Phil Choy
Friday, 21 November 2025
Project Manager
Sundale Developments
Suite 4.01, 13-15 Lyonpark Road, Macquarie Park NSW 2113
Email: phil@sundaleddevelopments.com.au

Response to Department of Planning, Housing, and Infrastructure queries

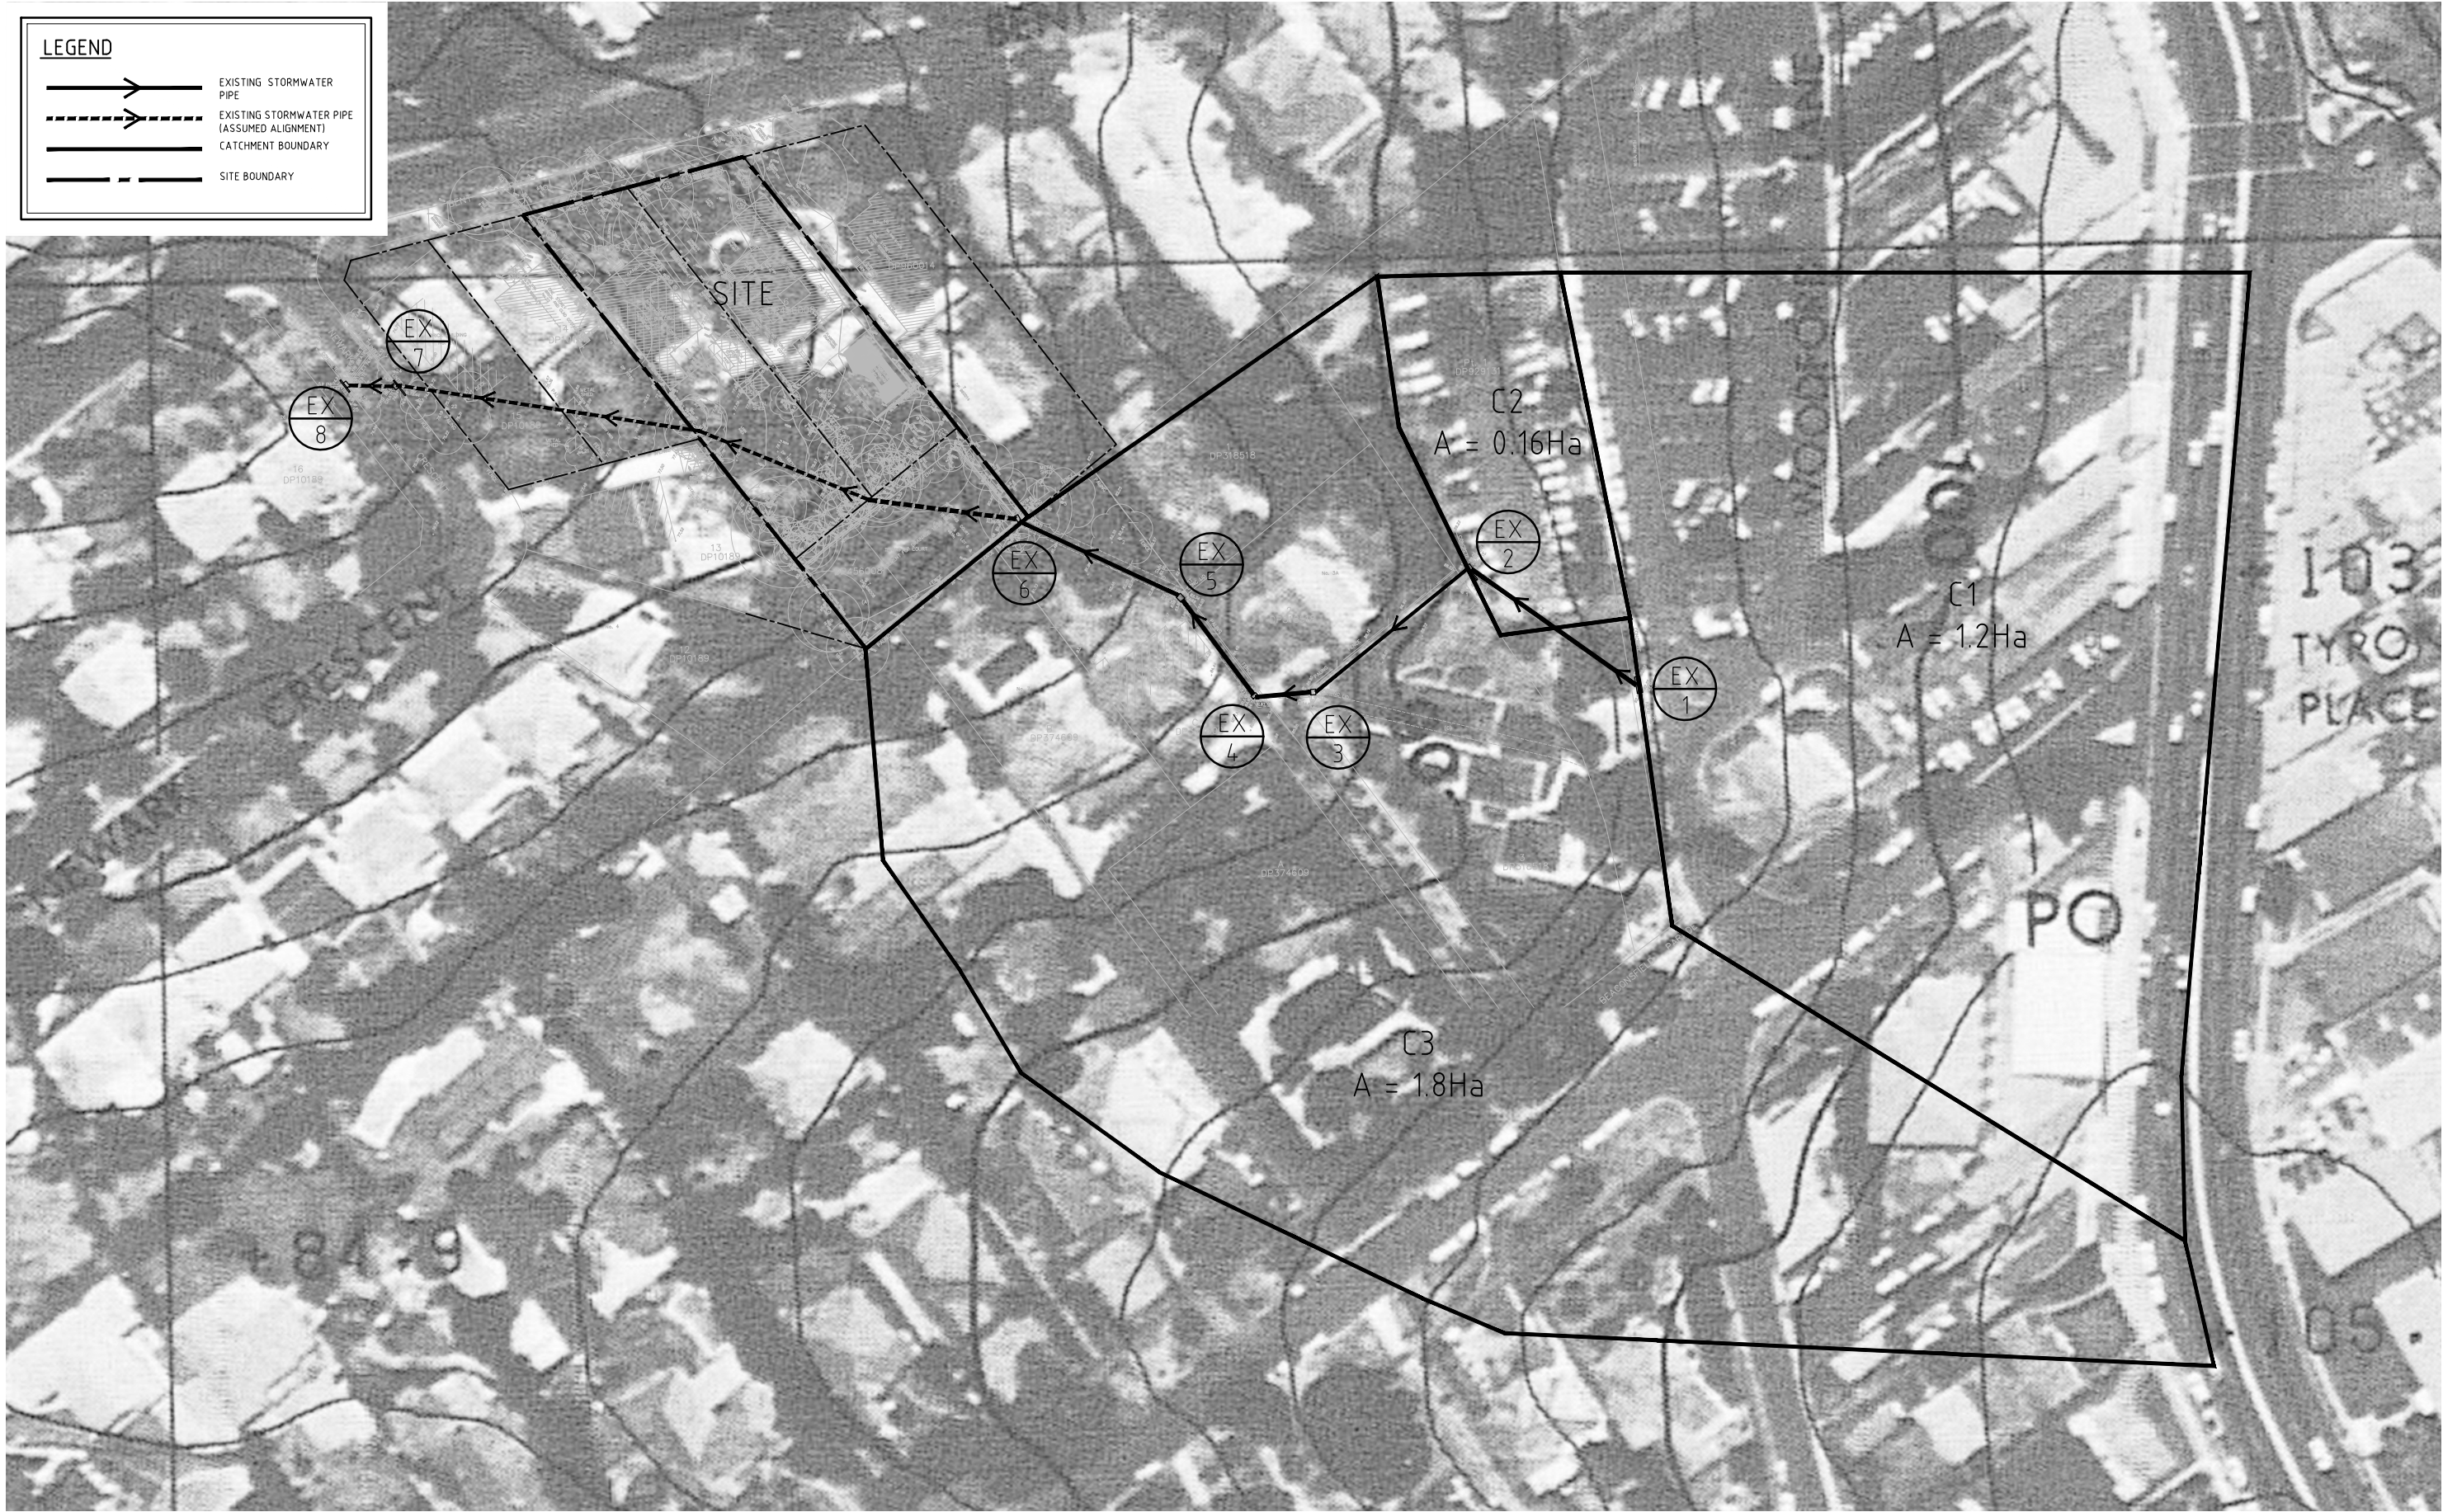
Comment	Response
<i>We note that the existing overland flow path is proposed to be diverted along the southern and western boundaries. One of the stormwater plans indicates that the overland flow path will connect to that within 18 – 20 Bent Street.</i>	
<i>Our understanding is that overland flow path is a natural path and therefore no connection is needed as such, as long as the pre and post water flows are the same.</i>	
<i>Notwithstanding, based on the note in the civil engineering plans, we request you provide us with the following confirmation from your engineer:</i>

a. <i>whether owner's consent is needed from 18 – 20 Bent Street, for this overland flow path connection, as mentioned in your submitted plans and the screenshot</i>	The downstream development (18-20 Bent Street) has designed and constructed their development under the assumption that all upstream flows will be conveyed through the overland flow path (refer to Appendix A and B). The proposed development does not depart from this design intent. Additionally, an existing Council drainage pipe lies within the 18-20 Bent St overland flow path, conveying upstream flows. This existing stormwater pipe and flow path has an existing easement dedicated for drainage.
